# Technical Service Bulletin

SUBJECT: <b>TORQUE CHANGE OF BOLTS FOR THE A/C CONTROL UNIT AND HAZARD WARNING LAMP SWITCH – SERVICE MANUAL REVISION</b>			NO.: <b>TSB-23-55-004</b>
			DATE: <b>March 2023</b>
			MODEL: <b>See below</b>
<b>CIRCULATE TO:</b>	<input type="checkbox"/> GENERAL MANAGER	<input checked="" type="checkbox"/> PARTS MANAGER	<input checked="" type="checkbox"/> TECHNICIAN
<input checked="" type="checkbox"/> SERVICE ADVISOR	<input checked="" type="checkbox"/> SERVICE MANAGER	<input checked="" type="checkbox"/> WARRANTY PROCESSOR	<input type="checkbox"/> SALES MANAGER

This TSB provides torque change information for the Interior, Chassis Electrical, and Heater, Air Conditioning and Ventilation sections of the Service Manual.

### HAZARD WARNING LIGHT SWITCH

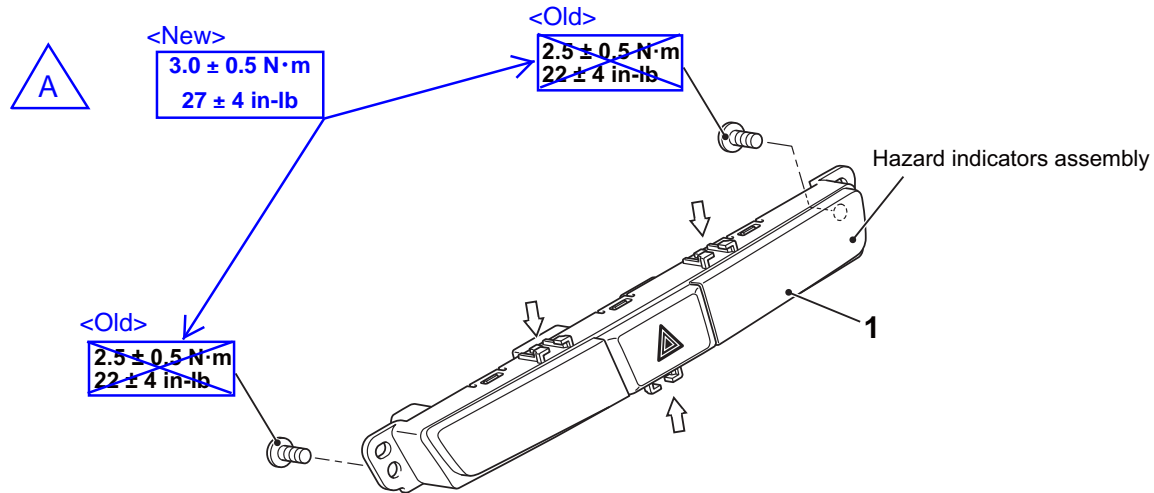
## CHASSIS ELECTRICAL HAZARD WARNING LIGHT SWITCH

# A/C CONTROL UNIT

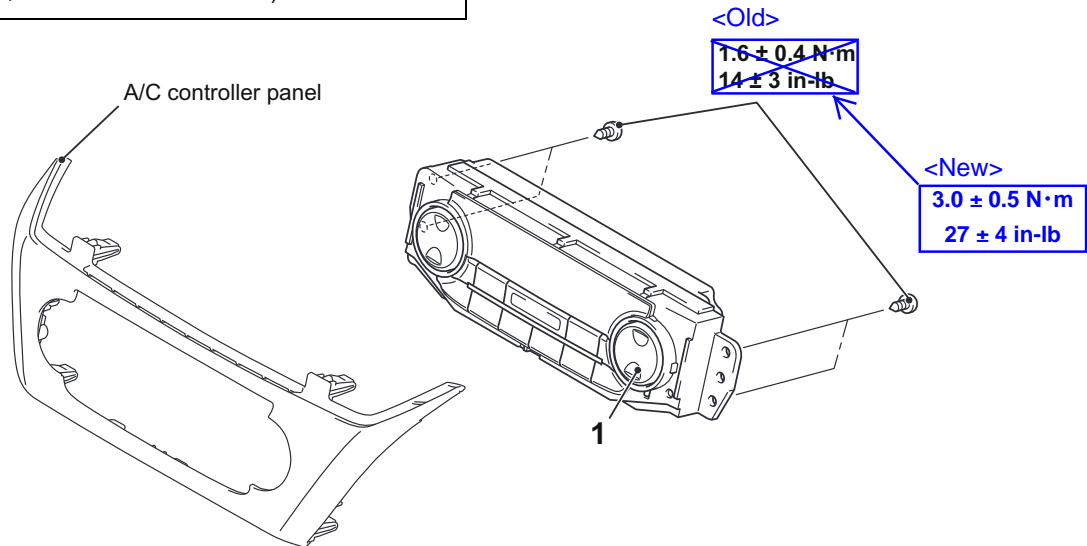
<Added>

<Added>

#### >>A<< A/C CONTROLLER ASSEMBLY INSTALLATION

Tighten the mounting screw to the specified torque in the order shown.

**Tightening torque: 3.0 ± 0.5 N·m (27 ± 4 in-lb)**
